N4692D-02

# Modification Recommended Service Note

## N4692D Electronic Calibration Module (ECal)

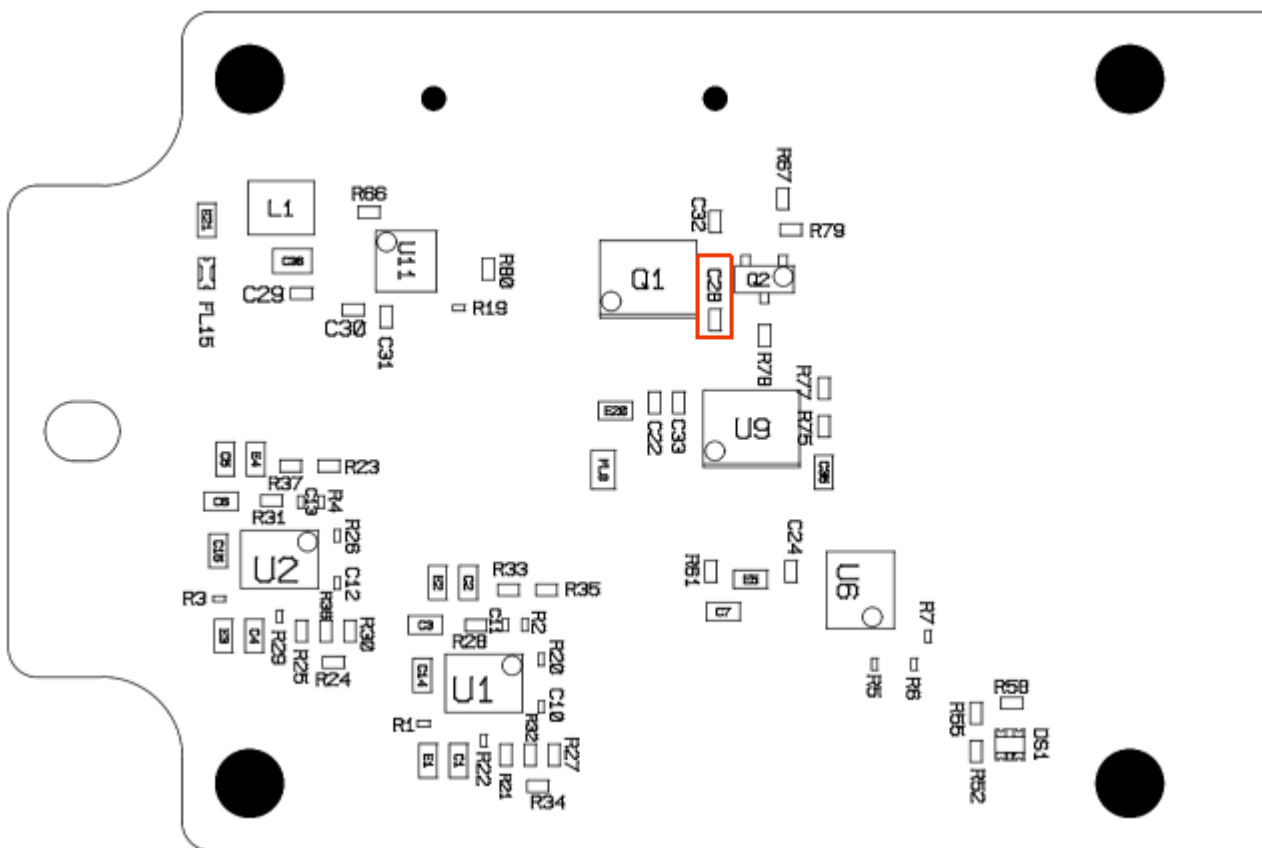
The heater circuit in the N469xD ECal modules was initially designed with a dampening capacitor. It was found in a small number of ECal modules that a resonance can develop in this circuit after the modules is warmed up. This resonance can cause an RF tone between 140 MHz and 150 MHz to be injected onto the signal path.

The dampening capacitor was eliminated in all ECal modules with serial prefix MY5941 and above.

Open the ECal module and remove the N4690-63004 printed circuit board. On this board, locate the C28 capacitor indicated here:

If this capacitor has been removed, no further action is required. Reassemble the ECal module.

If this capacitor exists on this board, this capacitor should be carefully unsoldered and removed, or the N4690-63004 printed circuit assembly should be replaced. Once this is done, reassemble the ECal module.
